**ADDENDUM NO. 1**

**May 29<sup>th</sup>, 2018**

**RE: Kelso Road & Burns Trail Sidewalks  
AHTD Job 061556  
Sherwood, Arkansas**

**FROM: GarNat Engineering, LLC  
2909 Military Road  
Benton, Arkansas 72015**

SHEET NO:  
**3**

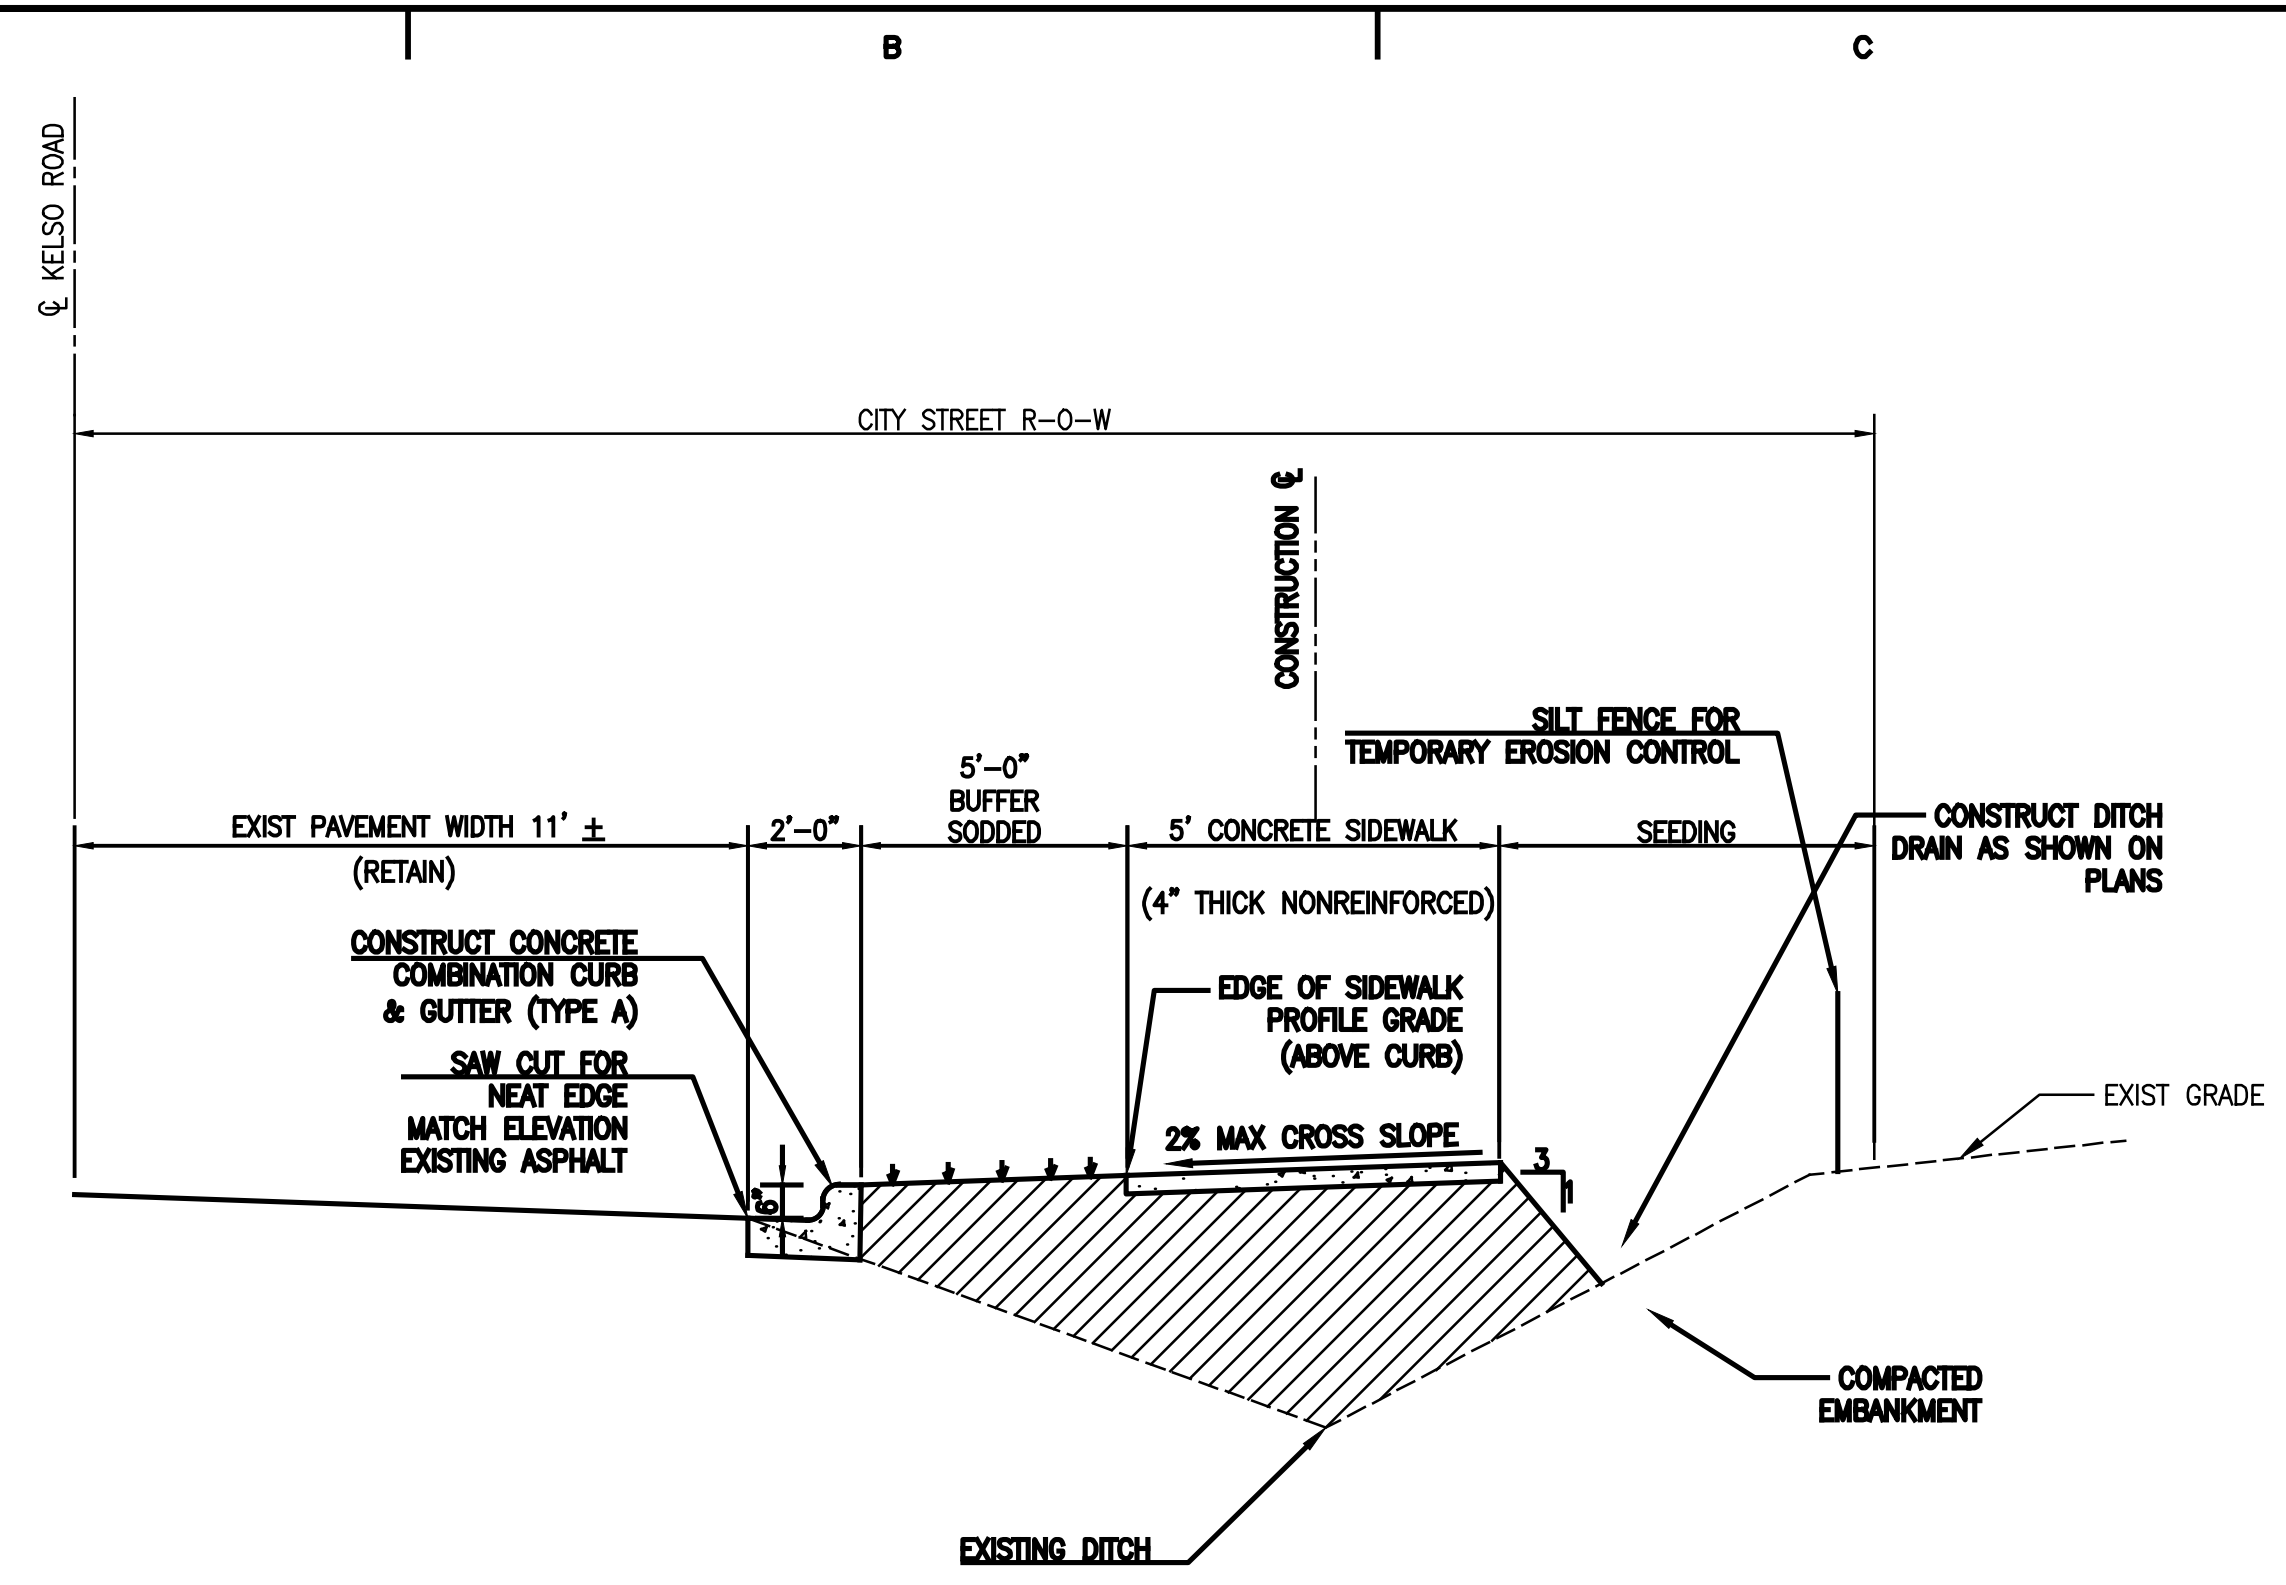
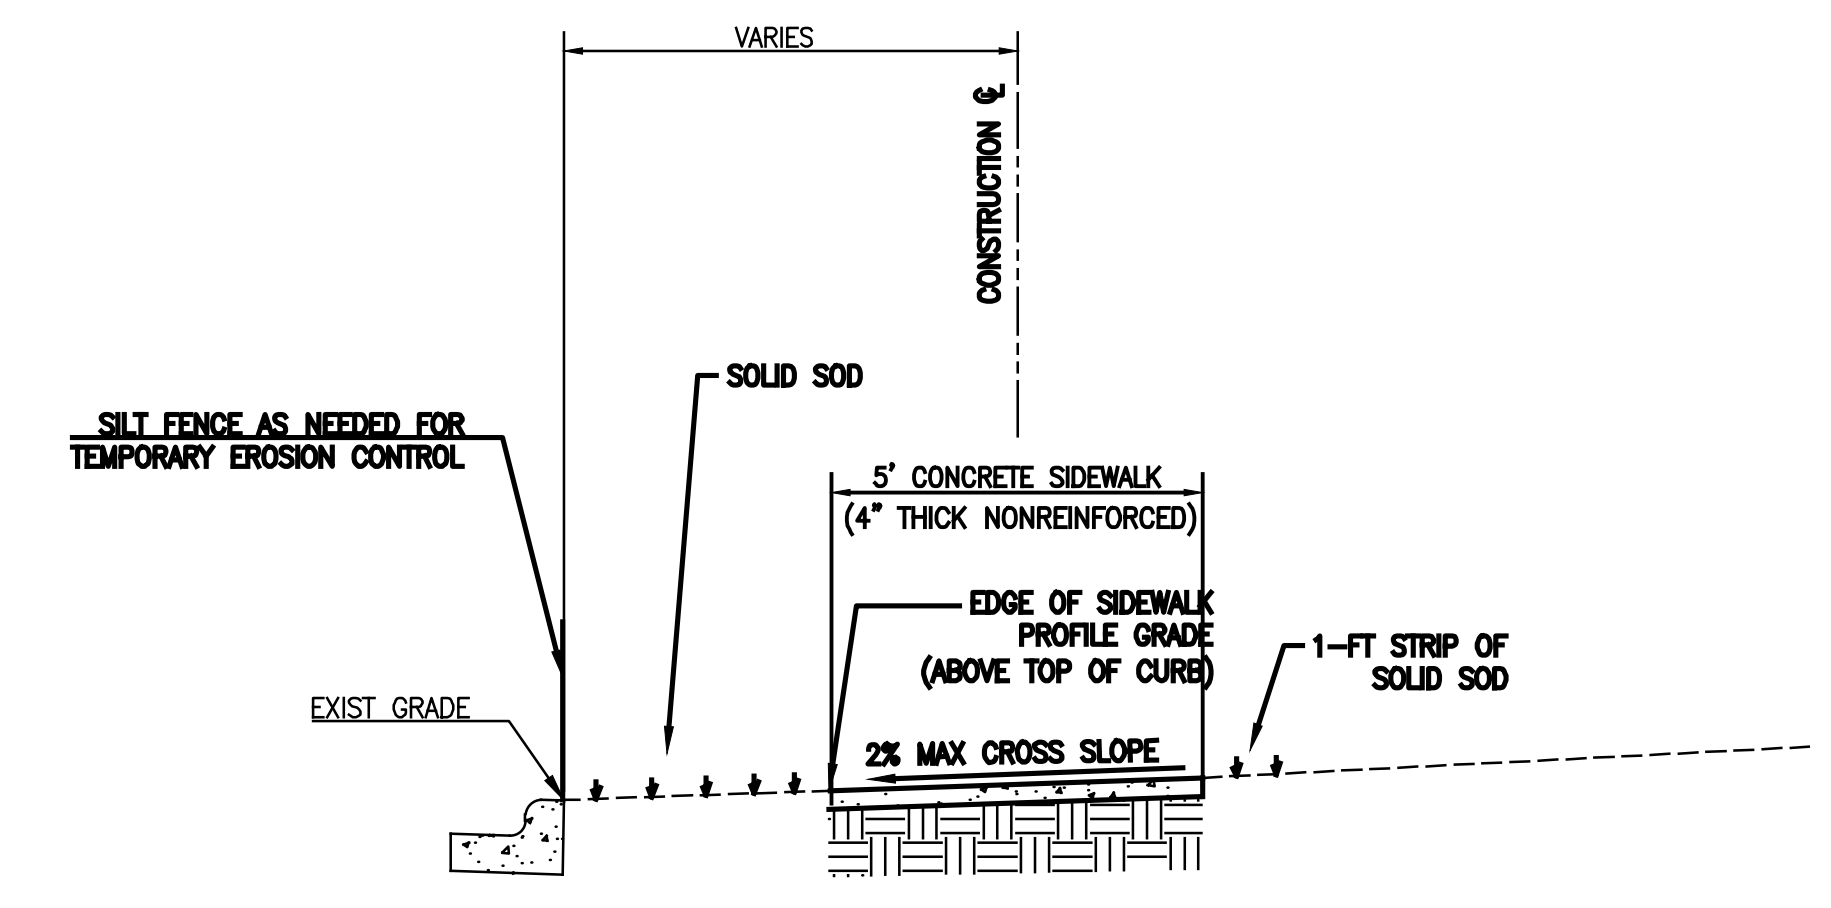
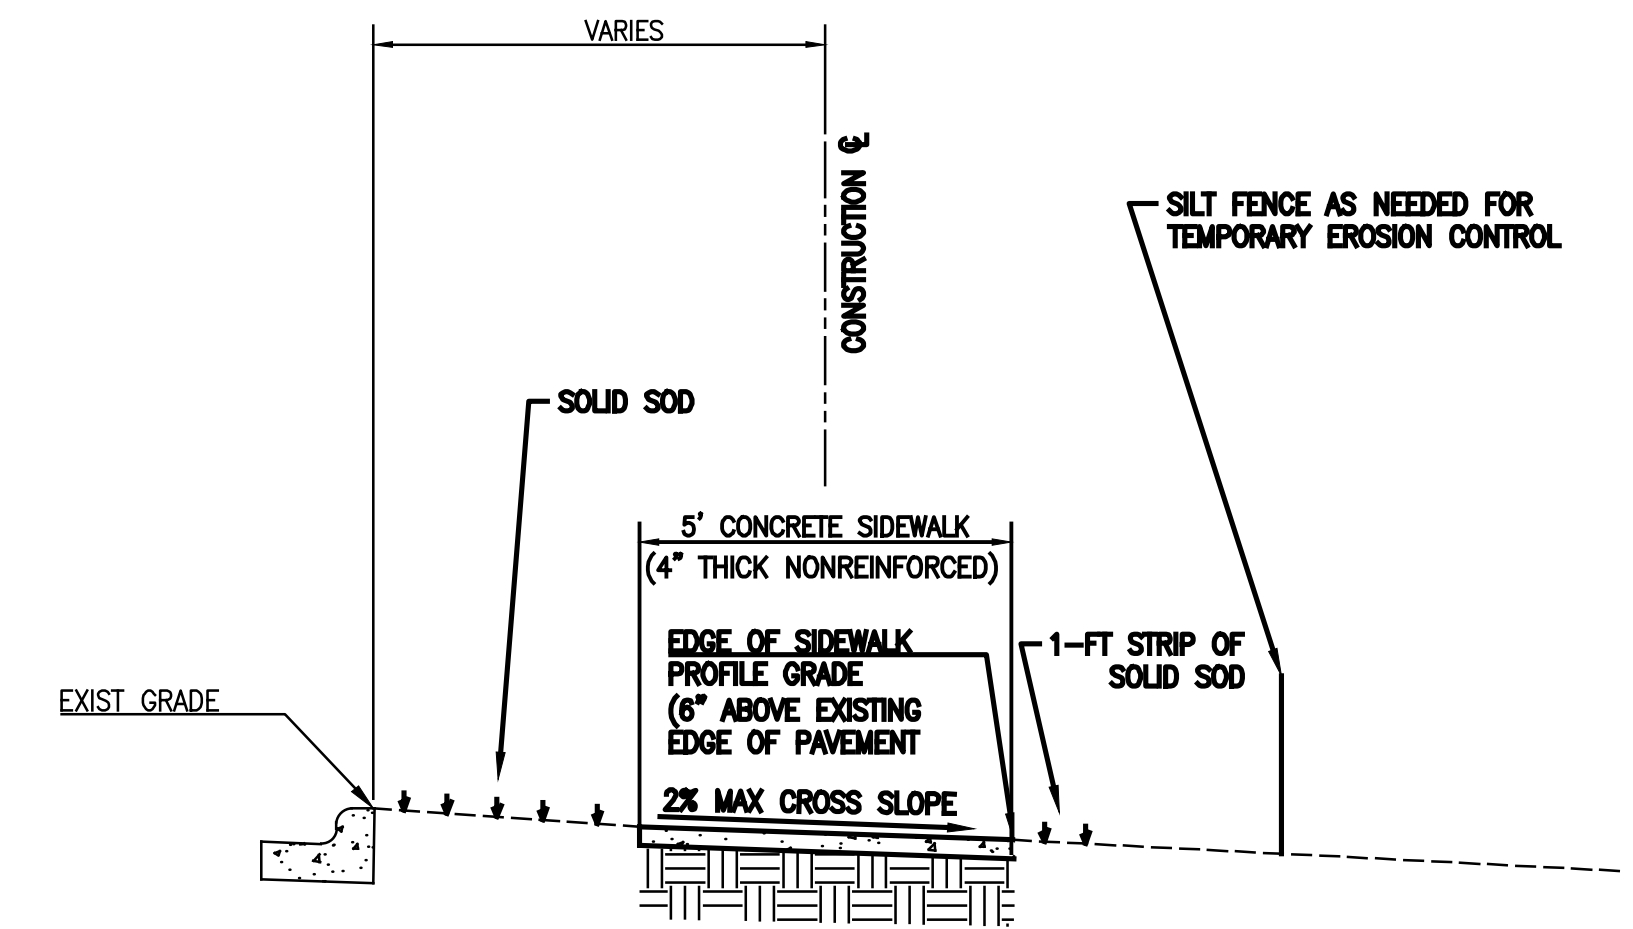
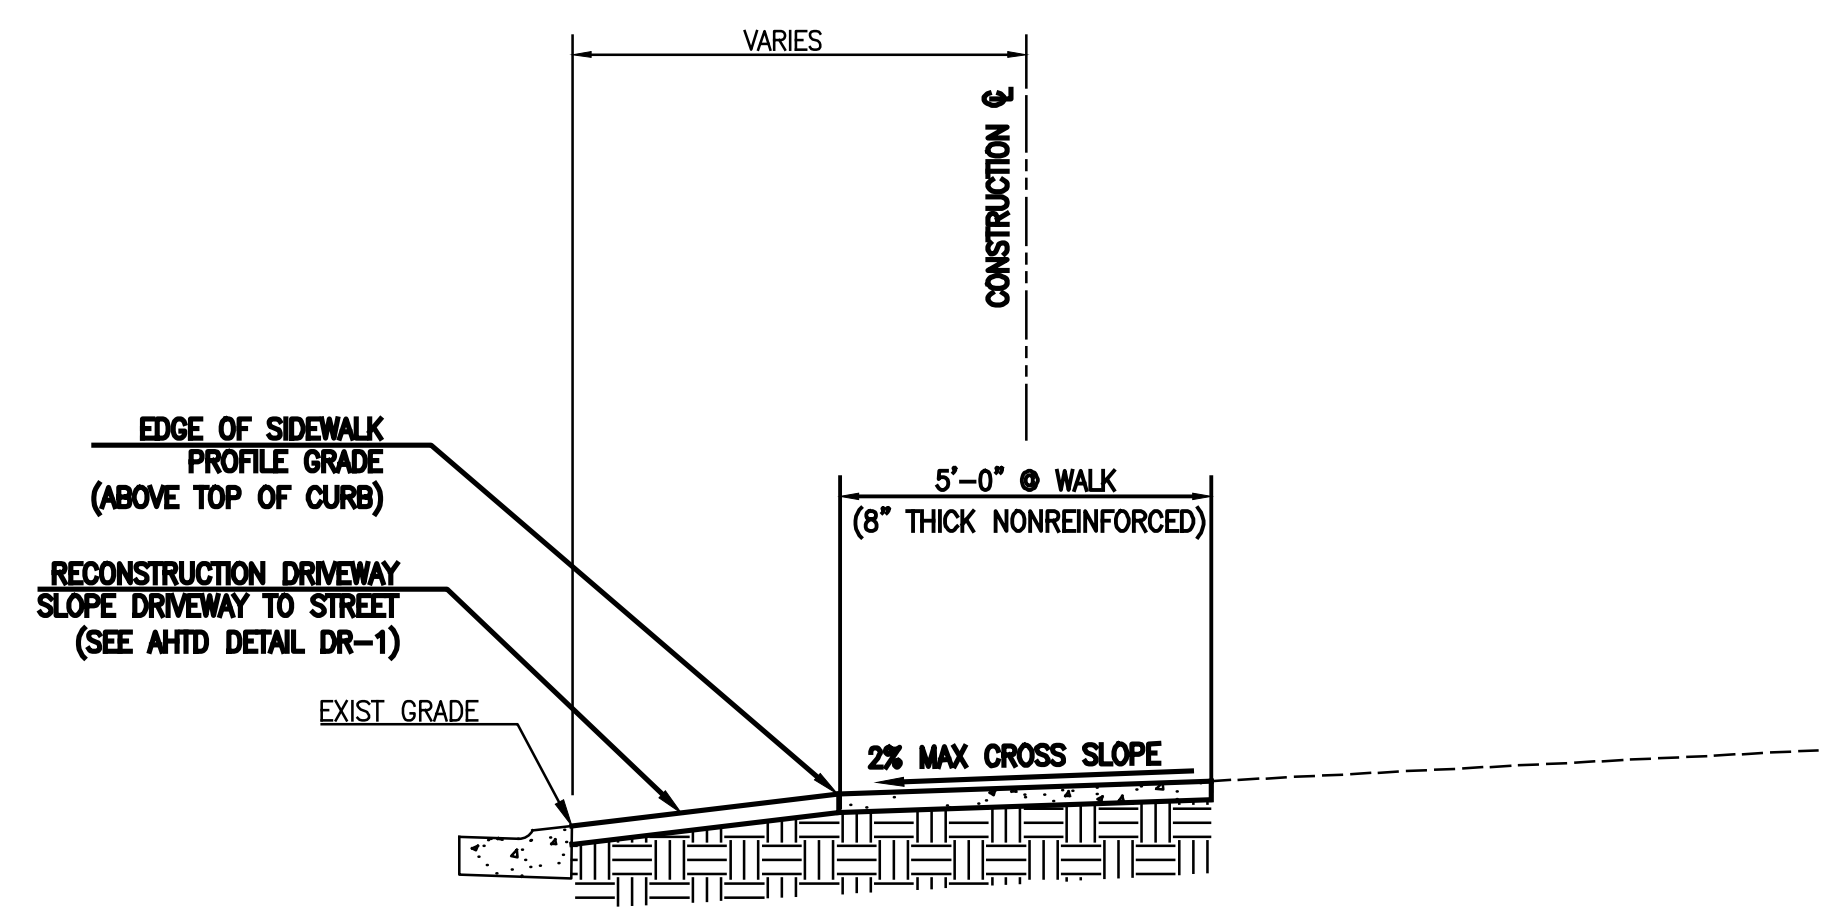
- C. Sheet 3 – Typical Sections
  - 1. Delete sheet and replace with enclosed document. Added locations for solid sodding on typical section.
- D. Sheet 6 – Summary of Quantities
  - 1. Delete sheet and replace with enclosed document.

BY	REVISION	DATE
KDV	#1 - ADDED SOD	5/29/18
